INFORMATION BULLETIN

Bulletin No: JC-015-08

Tach (35-096) Change

35-096 Tachometer

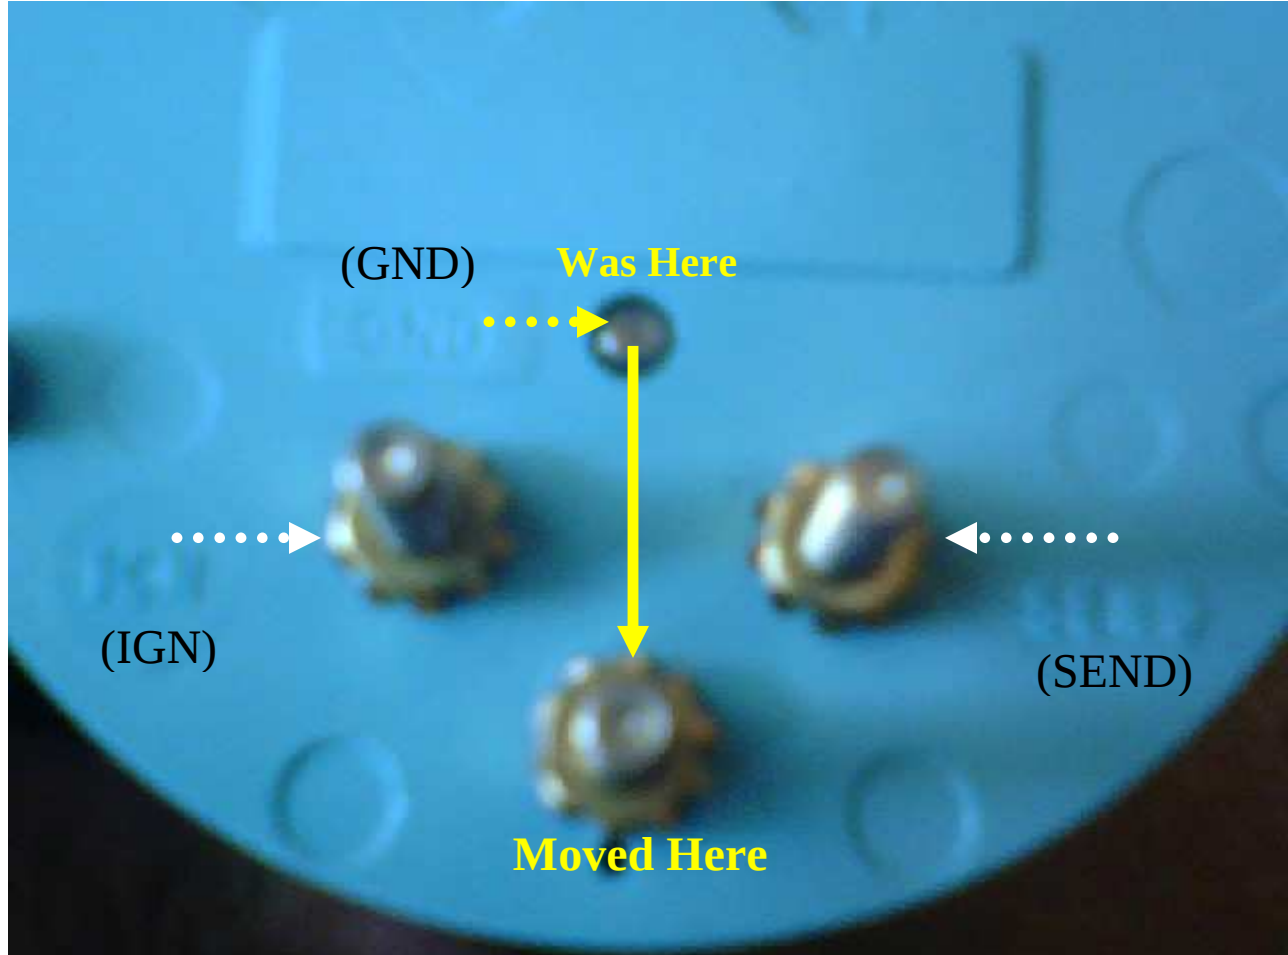
ISSUE: The manufacturer of our Tach 35-096 made a running change that is not self explanatory. They moved the location of the ground terminal but retained the original marked housing which makes it confusing as to the identification of the terminals.

THIS IS THE NEW CONFIGURATION

This was the original configuration

CORRECTION: Refer to the picture below. All they did was relocate the ground terminal. The Ignition and Sending terminals are still in the same location. Simply attach the ground terminal to the post shown and all will be fine.
